AGENDA

Greater Asheville Regional Airport Authority Regular Meeting
Friday, October 17, 2025, 8:30 a.m.
Council Chambers at Fletcher Town Hall
300 Old Cane Creek Road, Fletcher, NC 28732

D. Approval of Construction Contract Change Order No. 7 with Kokolakis Contracting for the Air Traffic Control Tower and Associated Facilities Project and Approve Owner Allowance Project Items (**document**)

E. Approval of Change Order No. 8 with Hensel Phelps for a Tower Crane and the Addition of a Construction South Access Road (**document**)

M-101 TRACON FLOOR PLAN - HVAC (SHEET 1 OF 9)
- Fire Smoke Dampers

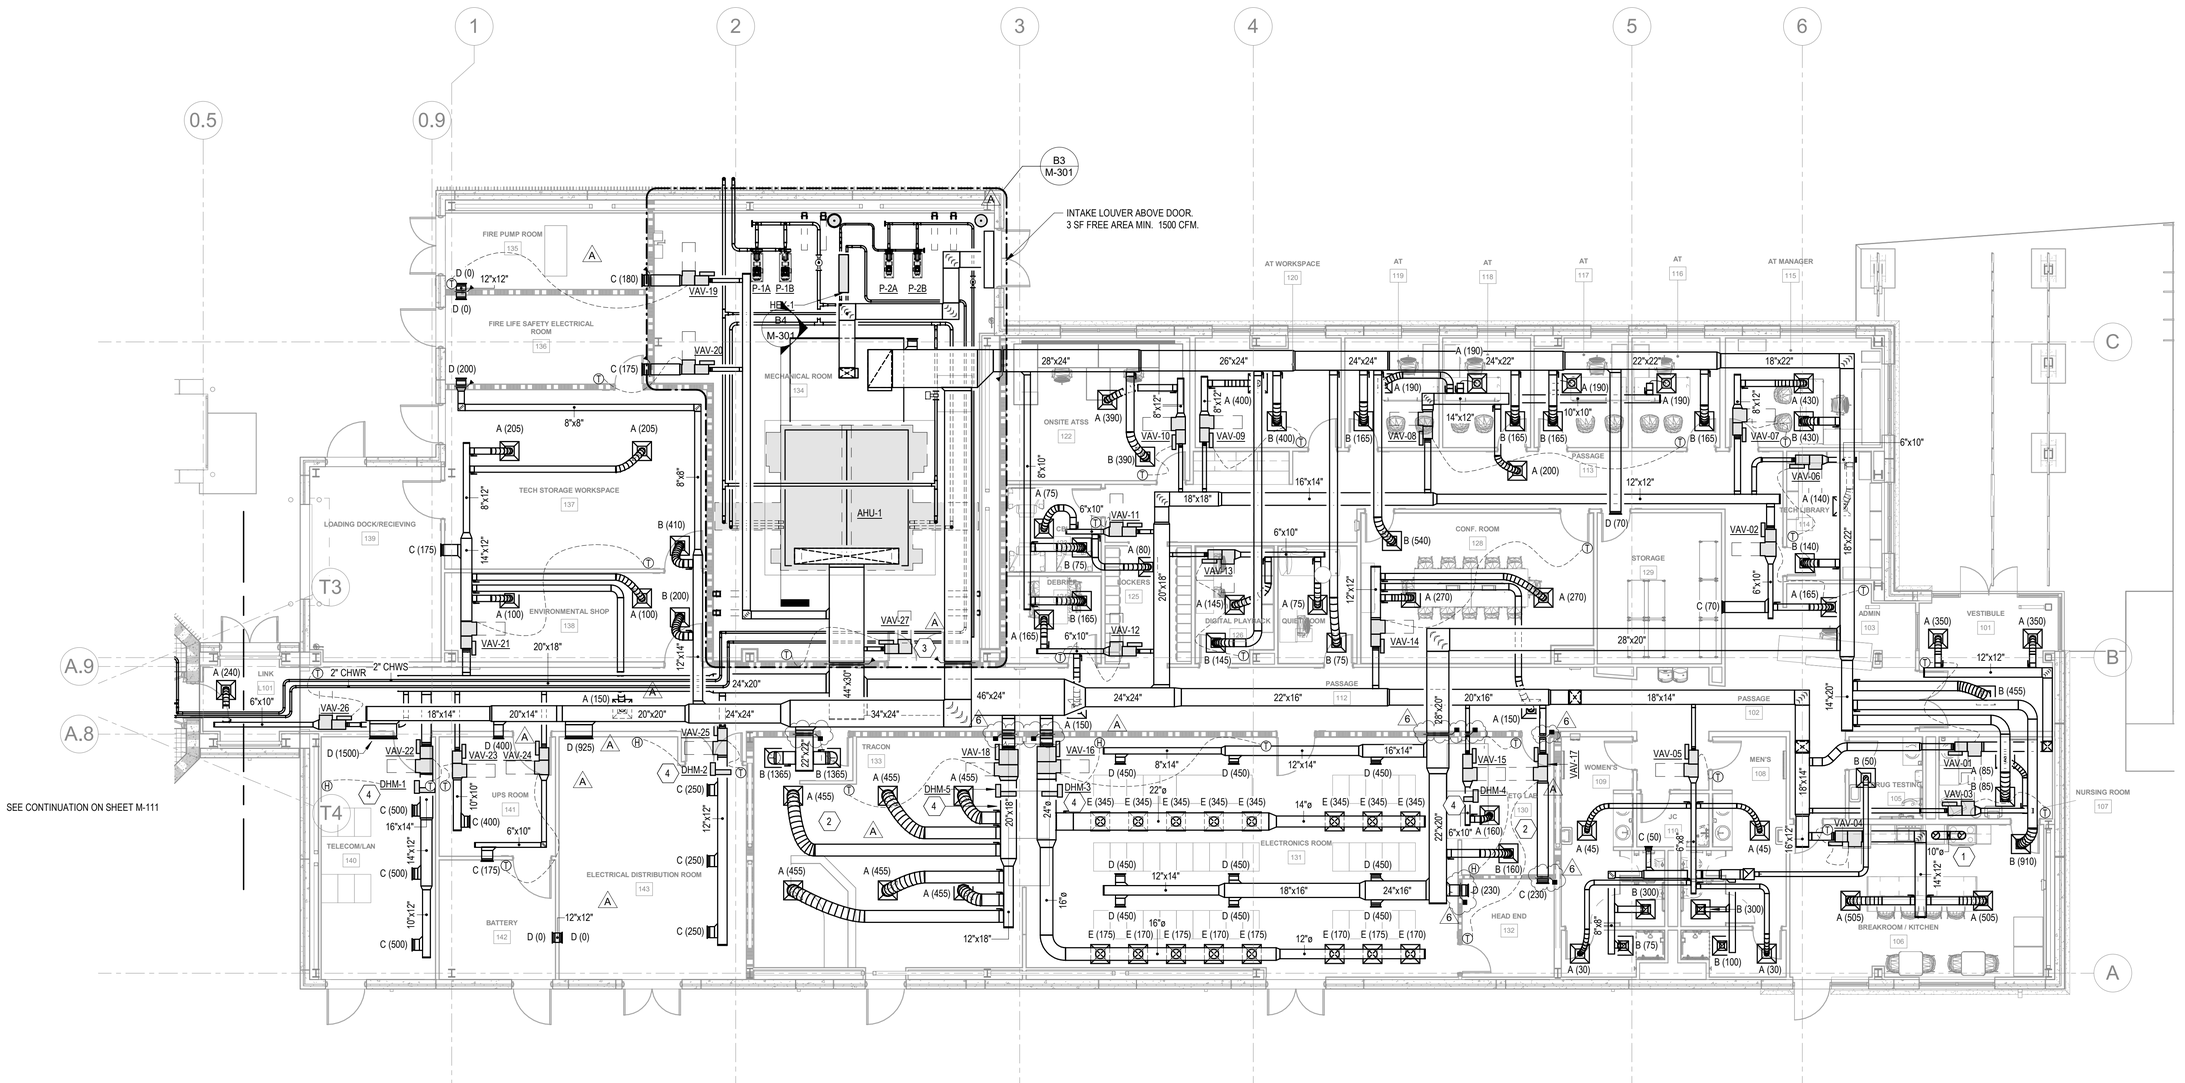
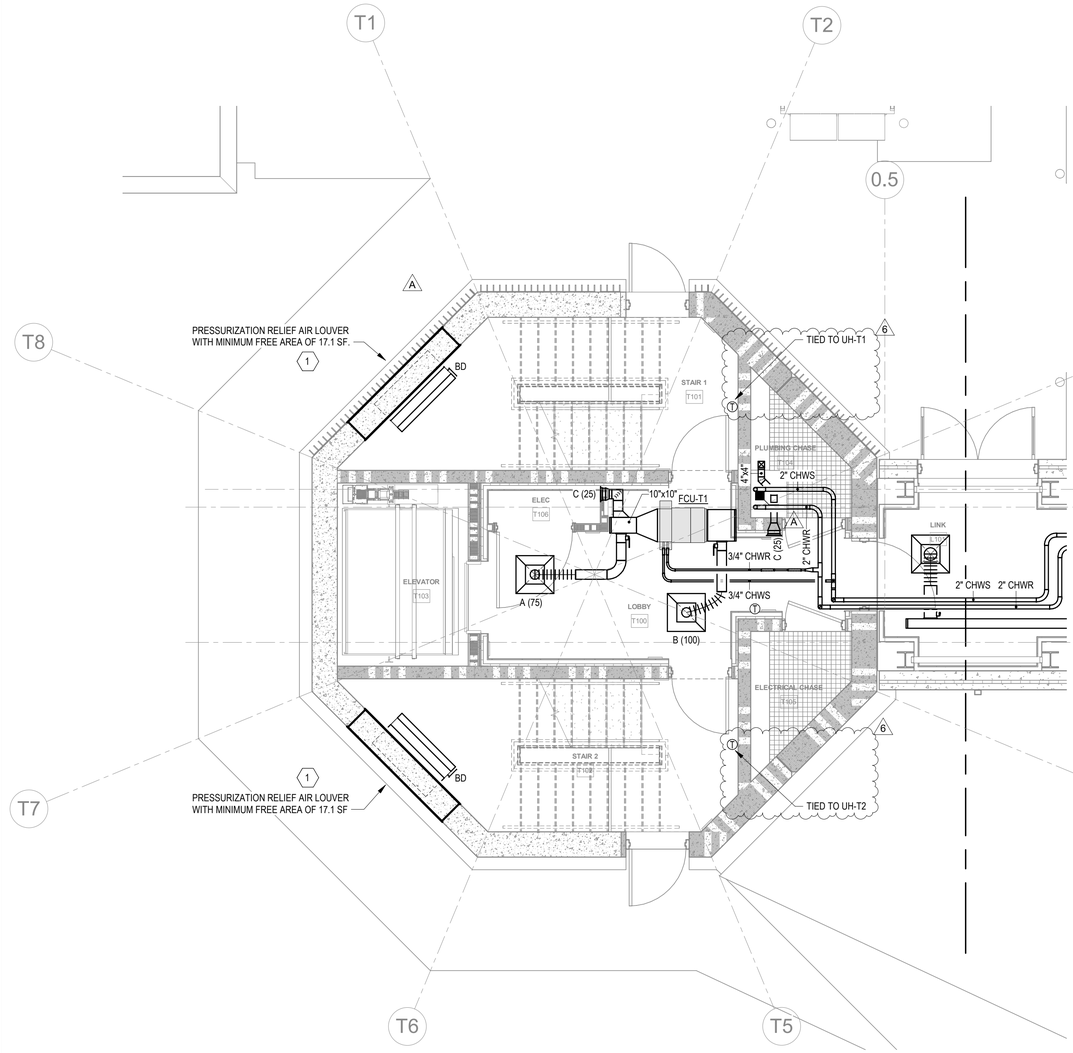
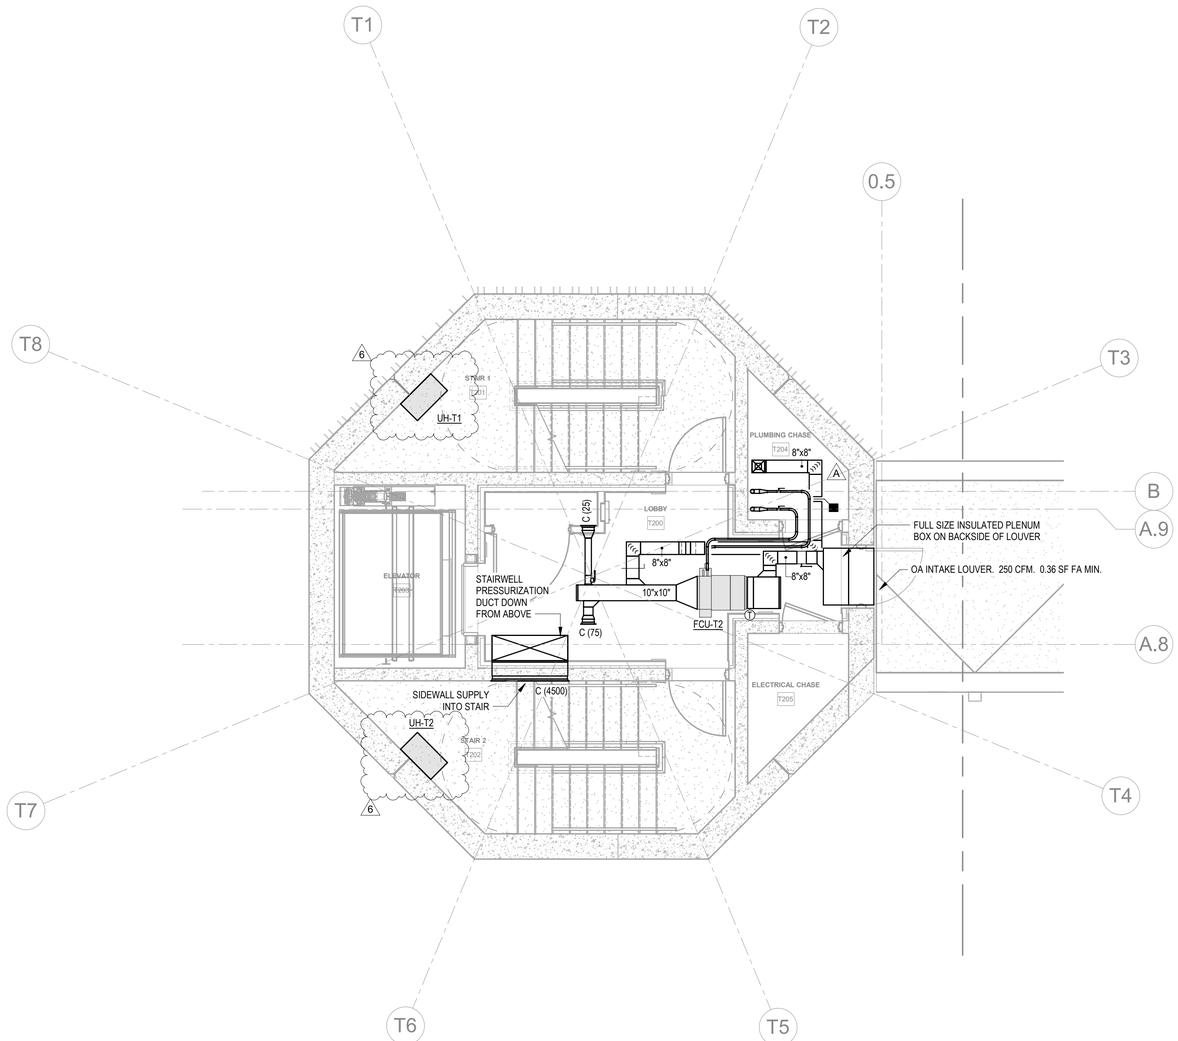
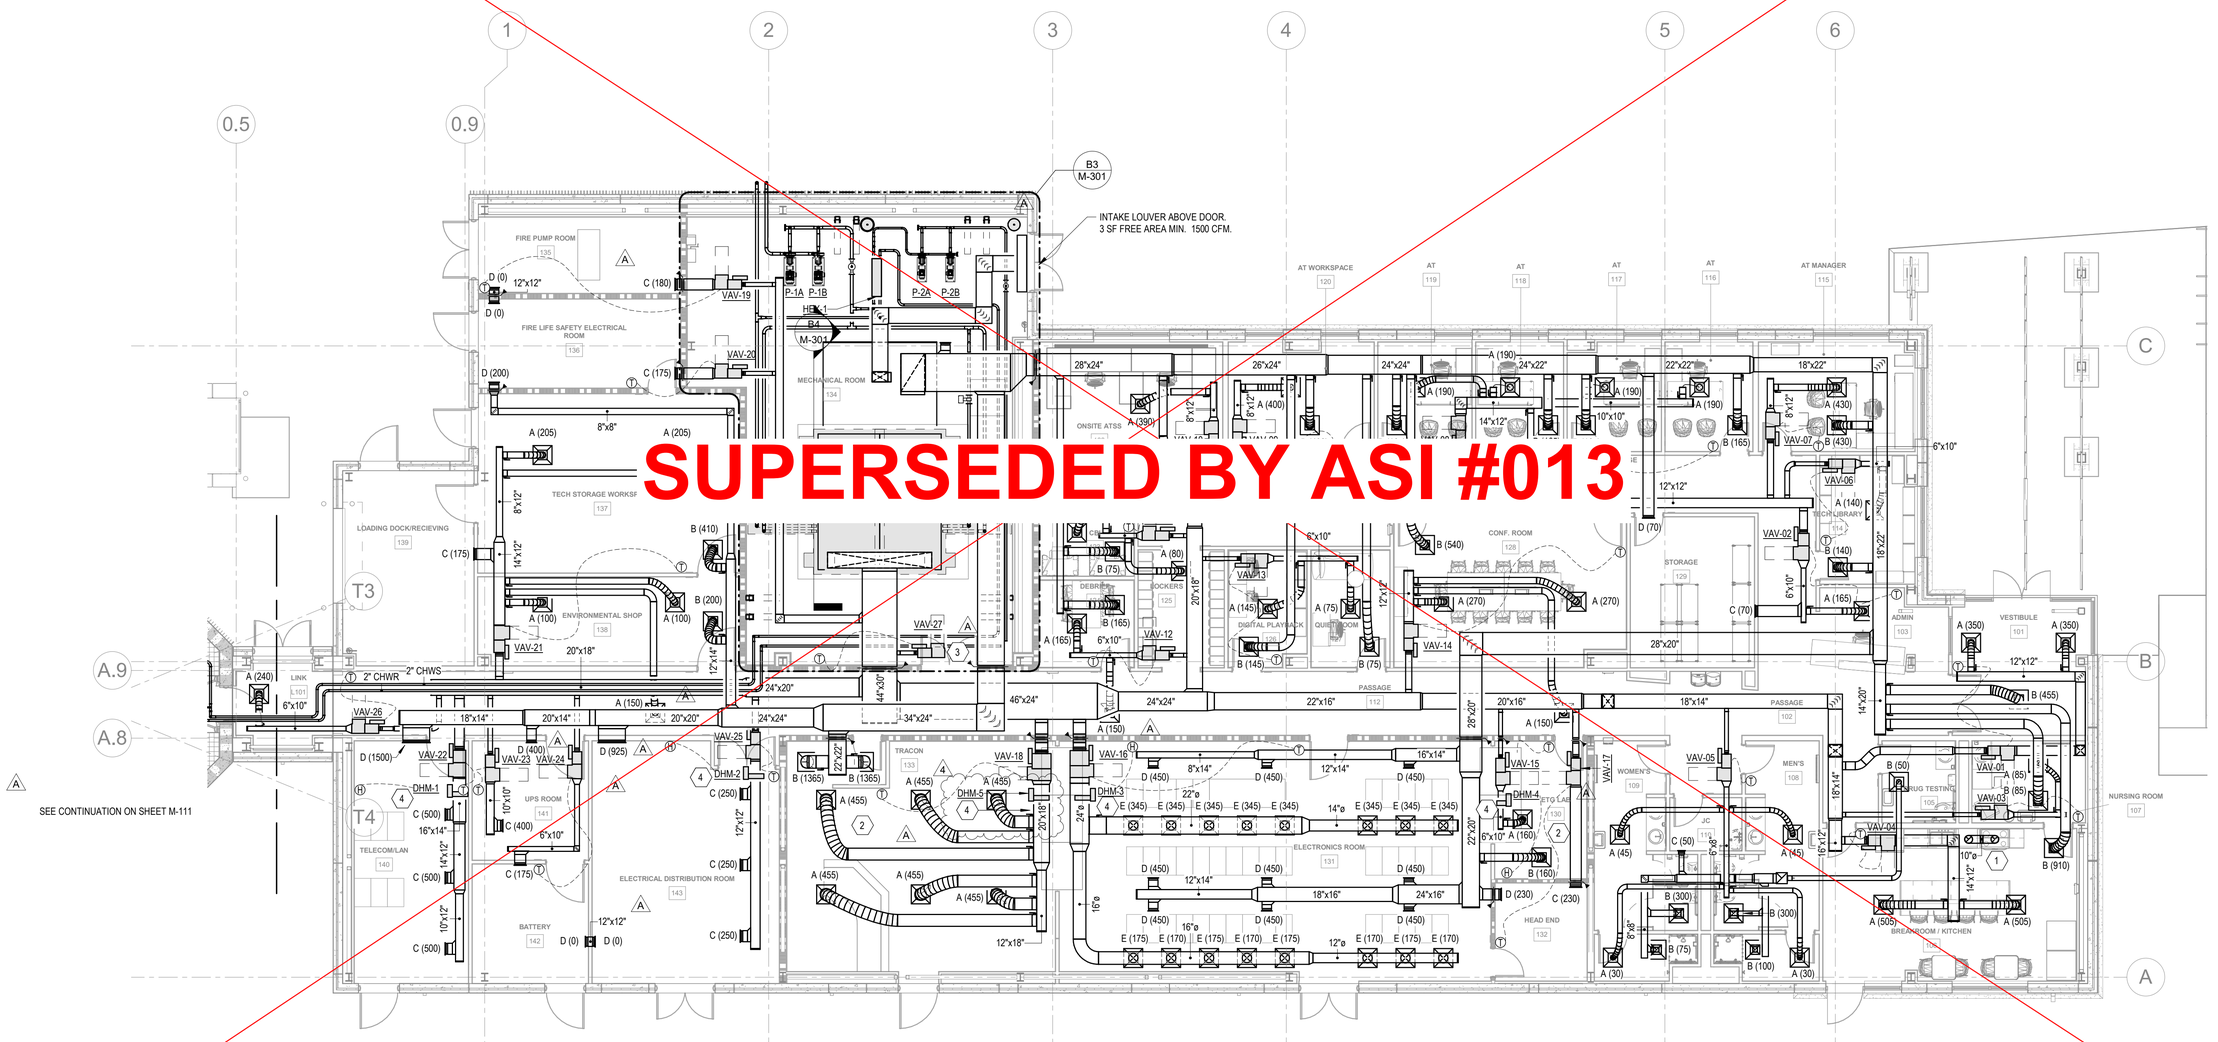
ASI-013 (07/24/2025), ISSUED FOR REVISIONS

SUPERSEDED BY ASI #013

A1 ATCT LIGHTING PLAN - LEVEL 2
SCALE: 1/4" = 1'-0"

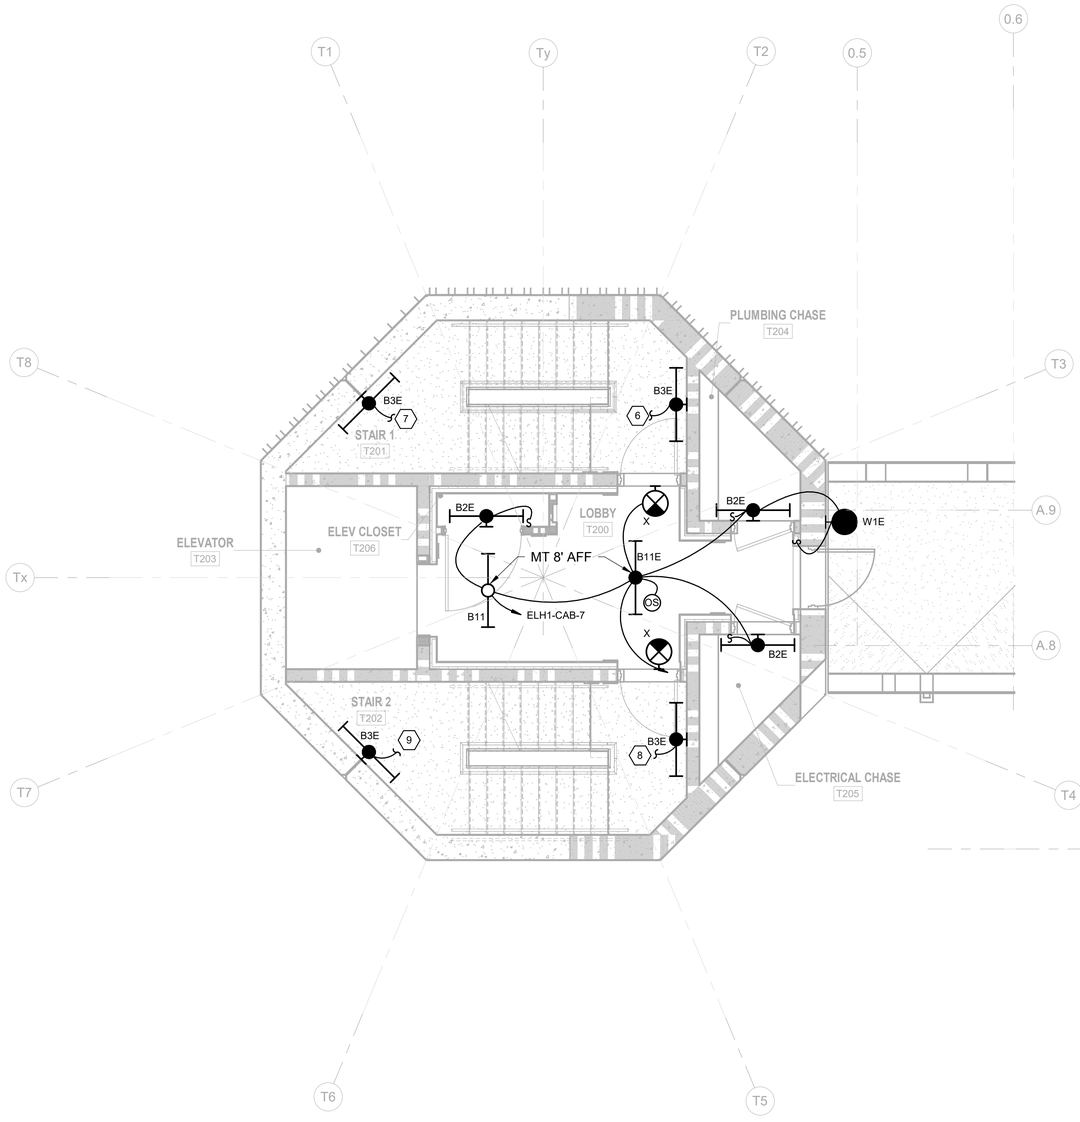
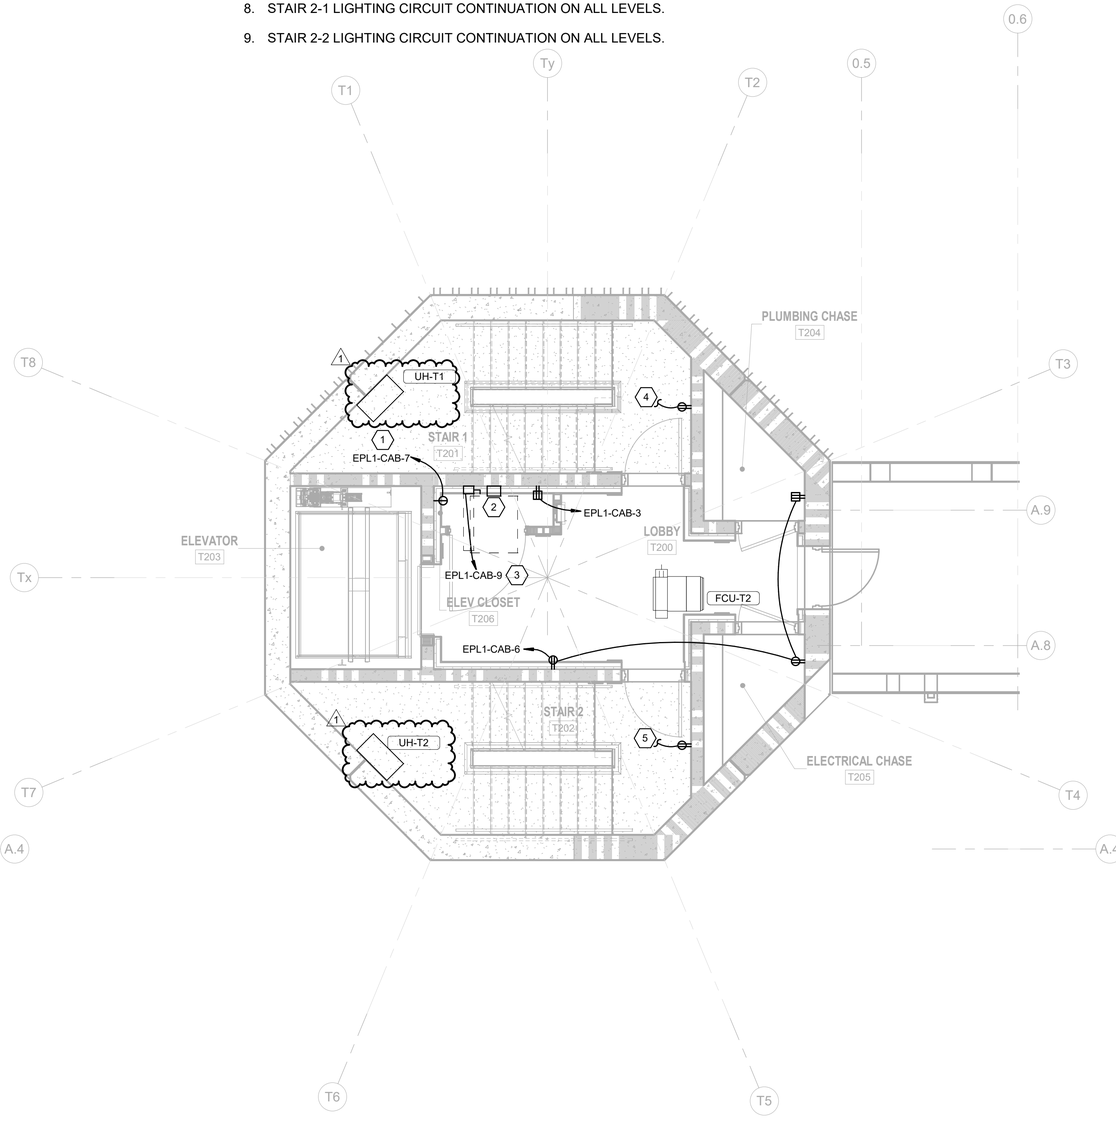
ASI-013 (07/24/2025), ISSUED FOR REVISIONS
